**COMMISSION OF ARCHITECTURAL REVIEW  
STAFF REPORT  
May 23, 2017, Meeting**

13. **COA-016178-2017** (D. Kleyman)

**966-968 Pink Street  
Union Hill Old and Historic District**

**Construct a new duplex.**

1905 Sanborn Map of the Subject Block

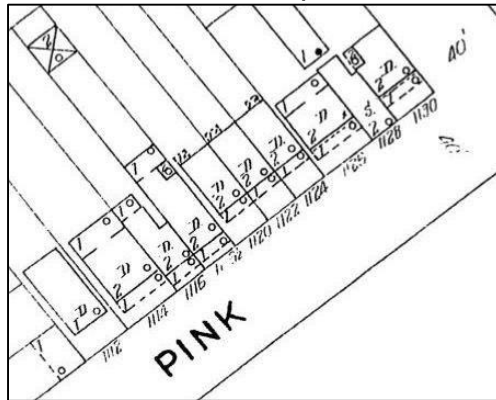
**Where the adjoining buildings have different setbacks, the setback for the new building should be based on the historical pattern for the block**

The historical pattern for the block involves buildings setback at various depths. The proposed setback is consistent with the most prevalent setback dimension.
